W3F1-2014-0064

Subject: Response to Waterford Steam Electric Station, Unit 3- Request for Additional Information Regarding a Change to the Updated Final Safety Analysis Report Clarifying Pressurizer Heaters Function for Natural Circulation (TAC No. MF3058)
Waterford Steam Electric Station, Unit 3 (Waterford 3)
Docket No. 50-382
License No. NPF-38

Waterford 3 Response to Request for Additional Information

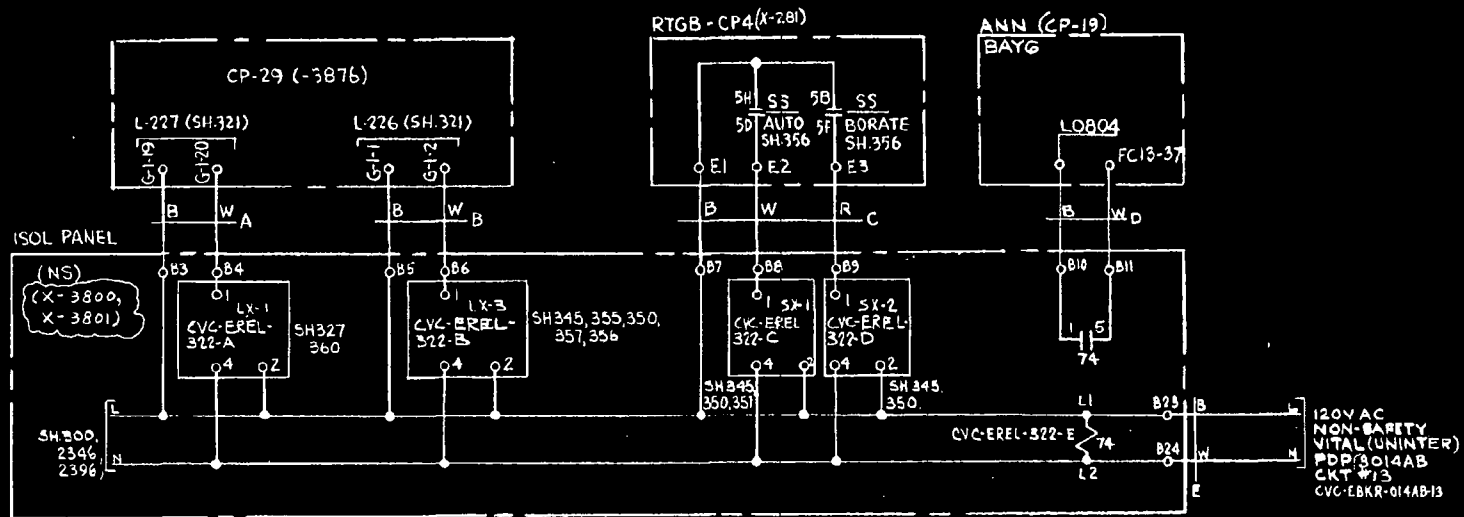
Please explain which alarm in the control room will help a control room operator identify whether the common circuit breaker, CVCEBKR014AB-13 is open. Provide a markup copy of the operating procedure which will then identify the need for the local manual operator action in the respective train switchgear room to reenergize the necessary Pressurizer Heaters.

Annunciator Alarm L0804 (H-4), Isol PNL CHNL NS Power Lost, would alarm in the Control Room to alert control room operators that CVCEBKR014AB-13 is Open. The below wording has been added to operations annunciator response procedure OP-500-010, Control Room Cabinet L, so

that if this alarm is received, the operators are aware of the potential impact to the Pressurizer Heaters.

The loss of power to CVC-EBKR-014AB-13 does not de-energize Switchgear 32A and 32B from the emergency power buses if they are already connected. However, Switchgear 32A Supply, SSD-EBKR-3A-8, and Switchgear 32B Supply, SSD-EBKR-3B-9, will not automatically close to load Switchgear 32A and 32B onto the Emergency Diesel Generators if they were initially open, such as during a Loss of the 3A or 3B Bus or during Loss of Offsite Power event. Also these breakers will not be able to be closed remotely (from the Control Room) to re-energize Pressurizer Heaters. If this condition affects Pressurizer Heater availability, then refer to Technical Specification 3.4.3.1 and Technical Requirements Manual 3.4.3.1.

LOU-1564
B-424
SHEET 322
4

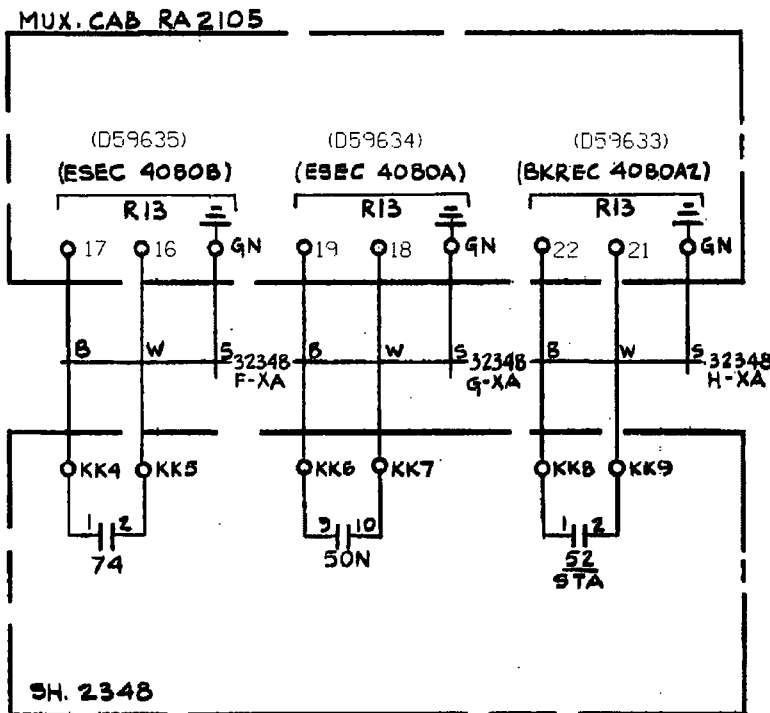
Please provide electrical schematic drawings that show how the common control circuit breaker, CVCEBKR014AB-13, affects the control power close circuitry of the Supply Circuit Breakers to Switchgears 32A and 32B.

Drawing Number	Title	Description
B424 Sheet 322	Volume Control Tank Level and Boric Acid Pump Interlocks	This CWD shows the common power supply, PDP 3014AB Circuit 13, that powers the 52z relays.
B424 Sheet 2346	STA Service Transformer 3A32 Feeder Interlocks	This CWD shows the wiring diagram for the 52z relay associated with the Station Service Transformer 3A32.
B424 Sheet 2396	STA Service Transformer 3B32 Feeder Interlocks	This CWD shows the wiring diagram for the 52z relay associated with the Station Service Transformer 3B32.
B424 Sheet 2348	Station Service Transformer 3A32 Feeder	This CWD shows the control circuit for Station Service Transformer 3A32 Supply Circuit Breaker.
B424 sheet 2398	Station Service Transformer 3B32 Feeder	This CWD shows the control circuit for Station Service Transformer 3B32 Supply Circuit Breaker.
